Agenda Item # 32

SUB-003731-2026 & ZON-UDC-003732-2026

Sunset Estates Subdivision

APPLICATION NUMBER	32	DATE	July 16, 2026
APPLICANT	Sunset Estates Subdivision		
REQUEST	Subdivision, Rezoning from R-1 and B-2 to R-1 and B-3

SITE PLAN

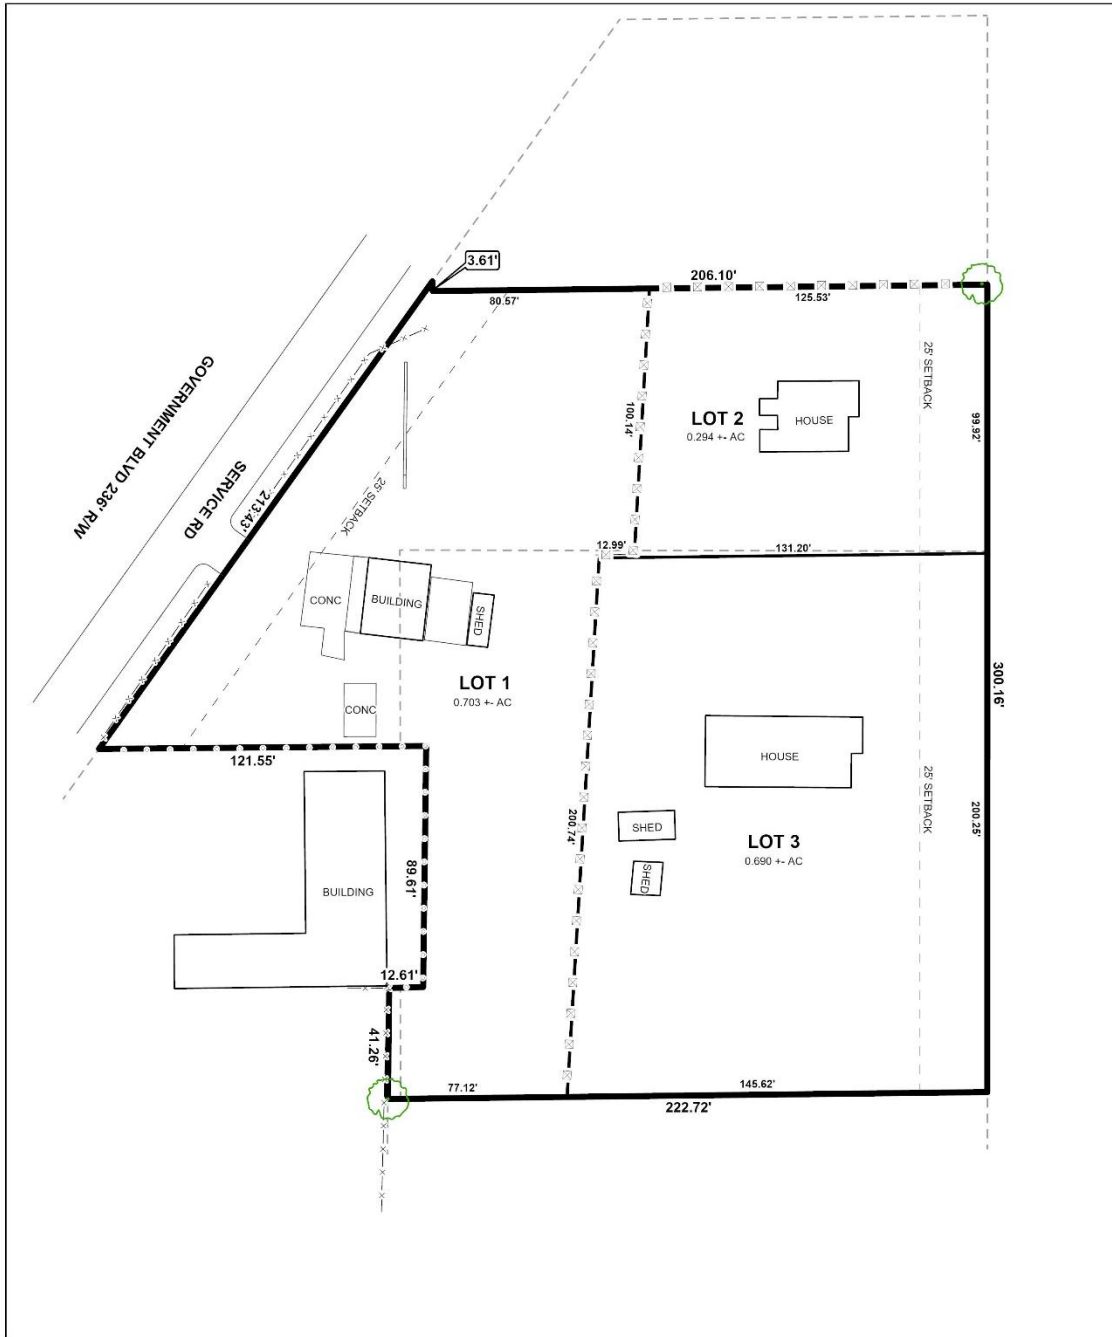
Proposed Lot 1 fronts Government Boulevard, an Alabama Department of Transportation-maintained Principal Arterial Street requiring a 250-foot-wide right-of-way at this location. Proposed Lots 2 and 3 front Mandrell Street, a minor street with curb and gutter improvements requiring a 50-foot-wide right-of-way.

The preliminary plat depicts Government Boulevard with a 236-foot-wide right-of-way. Therefore, if approved, the Final Plat should be revised to provide sufficient dedication to establish 125 feet from the centerline of Government Boulevard, unless a waiver of Section 6.B.9. of the Subdivision Regulations is approved upon recommendation of the City Engineer and Traffic Engineer. No additional right-of-way dedication is required along Mandrell Street.

All proposed lots exceed the minimum lot area requirements of Article 2, Sections 64-2-5.E. and 64-2-14.E. of the Unified Development Code (UDC) for properties served by public water and sanitary sewer. The preliminary plat properly identifies the area of each lot in both square feet and acres. If approved, this information should be retained on the Final Plat, adjusted as necessary to reflect any required right-of-way dedication. A lot area table may be provided in lieu of individual lot labels.

A 25-foot front yard setback is depicted along both Government Boulevard and Mandrell Street, consistent with Section 6.C.8. of the Subdivision Regulations and the applicable requirements of the UDC. If approved, the setback should be retained on the Final Plat and adjusted as necessary to account for any required right-of-way dedication.

As submitted, approval of the subdivision would result in proposed Lot 1 being split-zoned between R-1 (Single-Family Residential Suburban District) and B-2 (Neighborhood Business Suburban District). Therefore, approval of the subdivision should be contingent upon approval of the associated rezoning application.

1. Revision of the plat to illustrate dedication sufficient to provide 125 feet from the centerline of Government Boulevard, unless a waiver of Section 6.B.9. of the Subdivision Regulations is recommended by the City Engineer and Traffic Engineer;

2. Retention of the 50-foot-wide right-of-way along Mandrell Street on the Final Plat;
3. Retention of the lot sizes in both square feet and acres, or the provision of a table on the Final Plat with the same information, adjusted for any required dedication;

4. Retention of the 25-foot front yard setback line along all street frontages, adjusted for any required dedication, in compliance with Section 6.C.8. of the Subdivision Regulations;
